- 1. Ninilchik Townsite 2024 Replat; KPB File 2024-082  
Johnson Surveying / KPB, Waldron, Franey  
Location: Missionary Avenue & Civil Corps Road  
Ninilchik Area**

**ITEM #1 - PRELIMINARY PLAT  
NINILCHIK TOWNSITE 2024 REPLAT**

<b>KPB File No.</b>	2024-082
<b>Plat Committee Meeting:</b>	AUGUST 26, 2024
<b>Applicant / Owner:</b>	Jacqueline Waldron & Gabriel Franey / Westport, WA Kenai Peninsula Borough / Soldotna, AK
<b>Surveyor:</b>	Jerry Johnson / Johnson Surveying
<b>General Location:</b>	Civil Corps Rd, Ninilchik

# Ninilchik Townsite Preliminary Plat

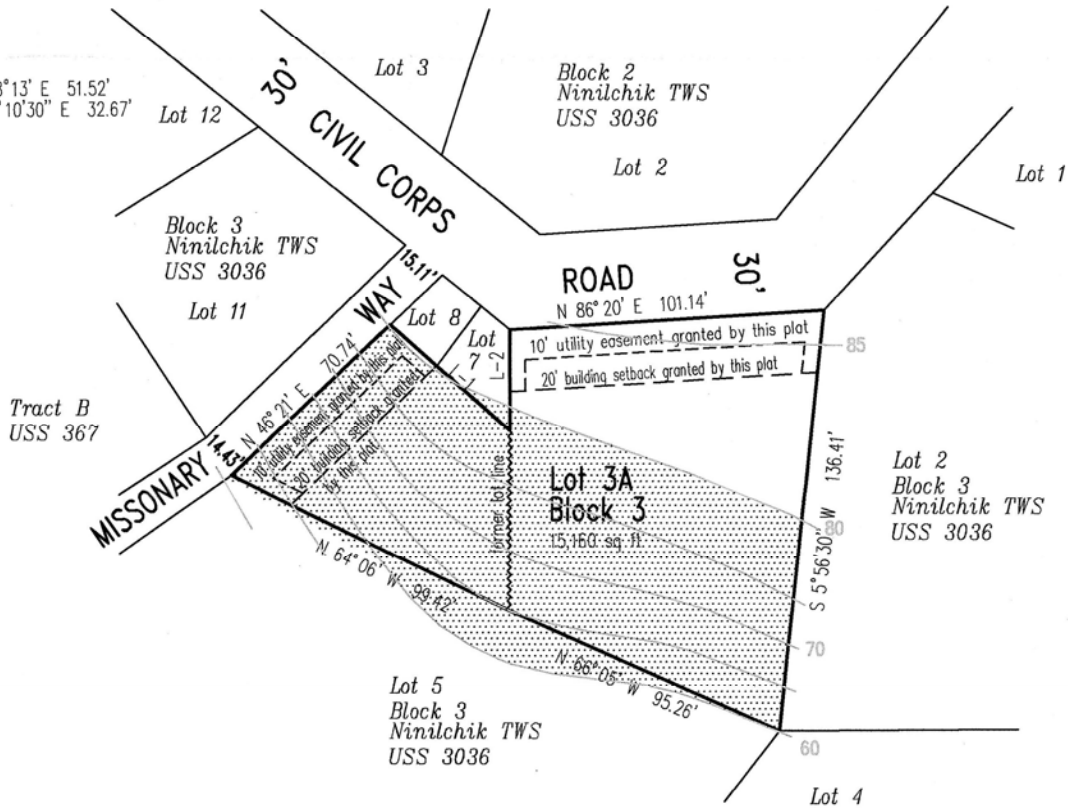
The plat does identify steep areas of over 20% fall by contours and shading. The steep areas cover a majority of the plat as shown. **Staff recommends** the contours be removed for the final submittal and replaced with directional arrows.

Correct the word appropriate in plat note #1.  
Check the font on plat note #1 for unity with the other plat notes.  
Check the font on the Wastewater Disposal note, it appears small than required.  
Add the KPB File no 20024-082 to the title block

- C. The location, width, and name of existing or platted streets and public ways, railroad rights-of-way, and other important features such as section lines or political subdivisions or municipal corporation boundaries abutting the subdivision;  
**Staff recommendation:**  
Correct the spelling of Missionary Way  
The width of Missionary Way is shown as 15.23' on the plat drawing, please verify correct size.

Oil Well is two words  
Orthodox Rd needs to be changed to Ave  
Add Section 4 to the southwest

Several adjacent lots need the block numbers added to the lot label.

# Ninilchik Townsite Preliminary 2024 Replat Plat

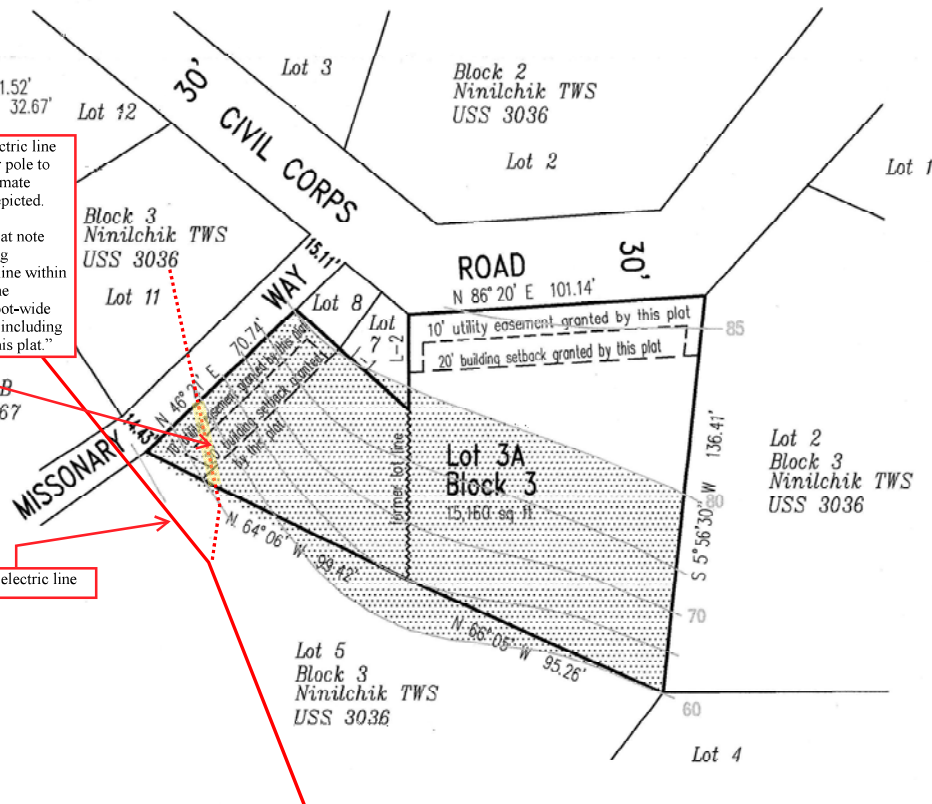
HEA REVIEWED - SEE COMMENTS

An underground electric line runs from the power pole to Lot 11. The approximate location has been depicted.

Provide a label or plat note stating, "The existing underground powerline within Lot 3A Block 3 is the centerline of a 15-foot-wide electrical easement, including pedestals, granted this plat."
